17 Eildon Road, St Kilda VIC 3182

Site Audit Report

Project No: 4712

City of Port Philip

Accessible entry door & ground floor door hardware (D-type lever handles)

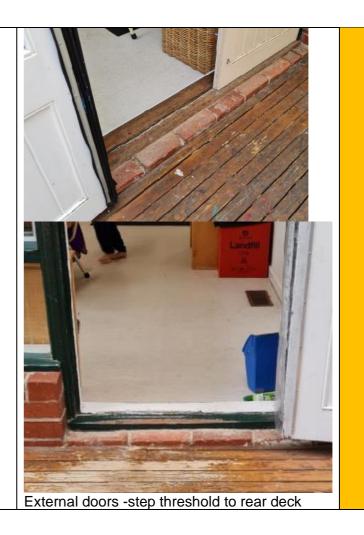
Component	Issue / Description Recommendation	Legislation Reference	Photos- External/Internal Doors	Priority
Main gate entrance, Principal entry door & internal/external doors typical	Entry gate - Intercom control located at 1300 mm AFL. Principal entry door – noncompliant clear opening width of 765mm, doorbell located at 1500 mm AFL. Alternate adjacent entry door to room OG 15 provides for compliant 850 mm clear opening width. All internal doors to ground & level 1 typically noncompliant clear opening widths ranging between 750-770 mm	AS1428.1, 2009 CI 13 & 14	Front entry gate & principal entry door	Medium
	Compliant door hardware provided to ground floor & non-compliant door hardware provided to level

1 doors located at 1150mm AFL.

Rear doors to deck – noncompliant clear opening width to single door 760mm & double door – active door leaf 800 mm clear, 75 mm step threshold provided.

Gate Intercom & doorbell to be relocated between 900-1100 mm AFL

Facility to be upgraded to provide compliant door openings/circulation space or Staff management plan to be provided for access to & within the building for a person with a disability.

Provide compliant door hardware – D-type lever handles to level 1 doors.

Rear stairway

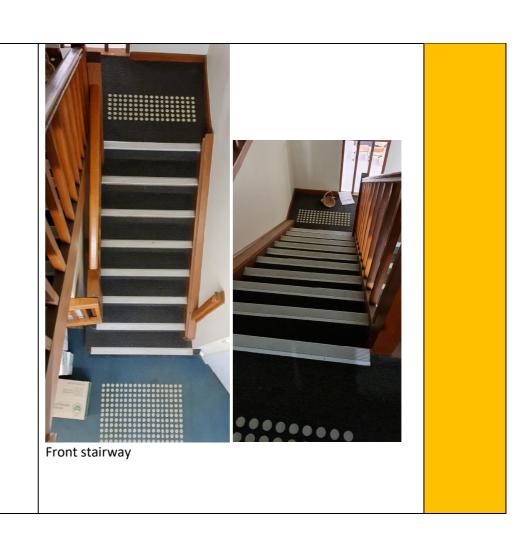
Component	Issue / Description Recommendation	Legislation Reference	Photos - External & Internal Stairs	Priority
External & internal stairs	External entry stair, no provision of compliant dual handrails, Stair nosing's & TGSIs Internal Stairs — Front stair - non-compliant single handrail, 1m clear provided between existing handrail & wall. Rear stair - non-compliant single handrail, 720 clear provided between existing handrail & wall, no provision of TGSIs to top & bottom of stairs No Provision of vertical lift access to first floor level.	(f) At the nosing, each tread shall have a strip not less than 50 mm and not more than 75 mm deep across the full width of the path of travel. The strip may be set back a maximum of 15 mm from the front of the nosing. The strip shall have a minimum luminance contrast of 30% to the background. Where the luminous contrasting strip is affixed to the surface of the tread. (h) TGSIs shall be installed in accordance with AS 1428.4.1. AS1428.1 Cl 11.2 (b) Handrails shall be installed on both sides of the stairs.	External entry stair	Medium

External stair – provide compliant dual handrails, stair nosing's & TGSIs.

Internal front stairprovide compliant dual handrails.

Internal rear stairprovide compliant single handrail.

Vertical lift access technically required to be provided to first floor level for a class 9b building.
